**AMENDMENTS TO THE DRAWINGS**

The attached sheet of drawings includes changes to Figure 1 showing a diagram of a battery system employing an inverter for outputting an AC voltage of a pre-established value and frequency. Support for the Amendment is provided at least on page 2, lines 1-3 and in Fig. 5, Fig. 6a, and Fig. 7a of the Specification for WO 031007464. Therefore, the Amendment raises no issue of new matter.

FIG.1

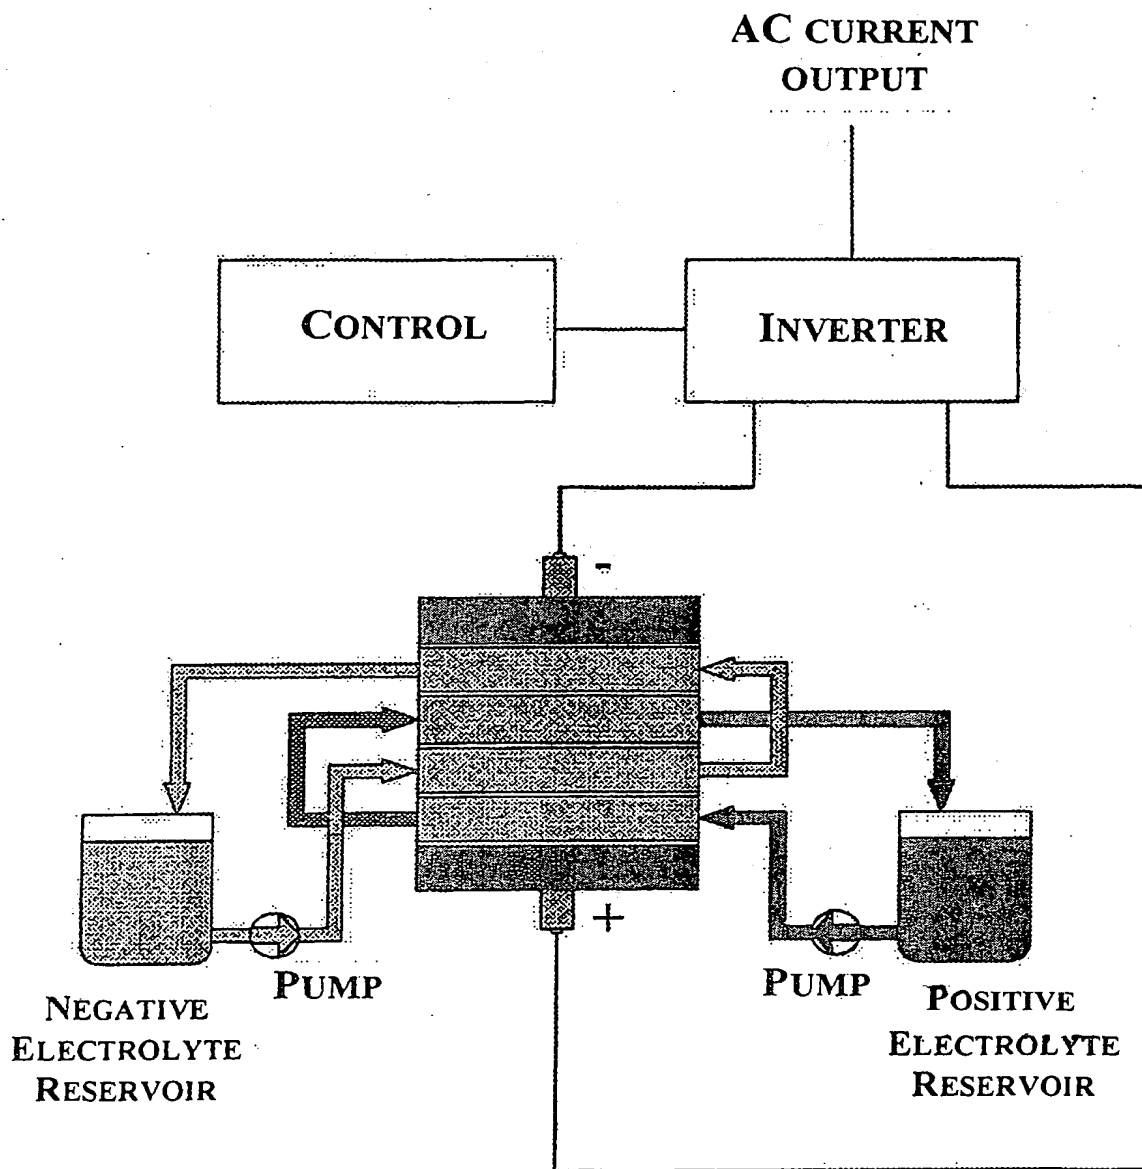
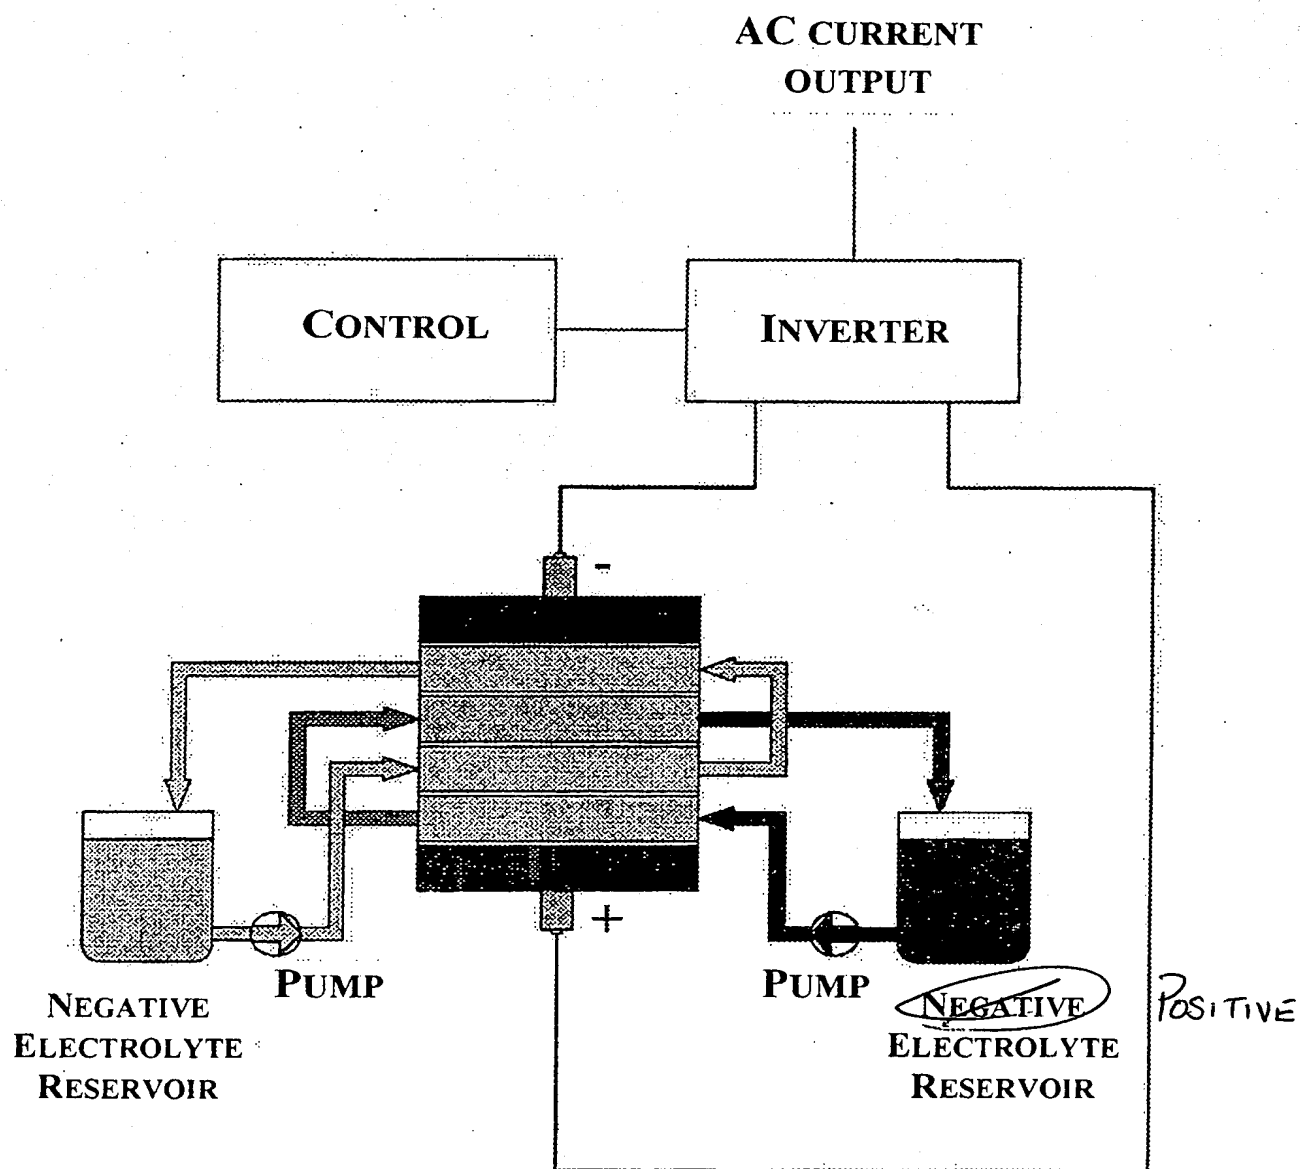
Applicant submits the attached replacement drawing sheet to correct the second occurrence of the label "Negative Electrolyte Reservoir" (on the right side of drawing) to read as "Positive Electrolyte Reservoir." An annotated drawing sheet showing the change(s) to be made is also provided for your reference.
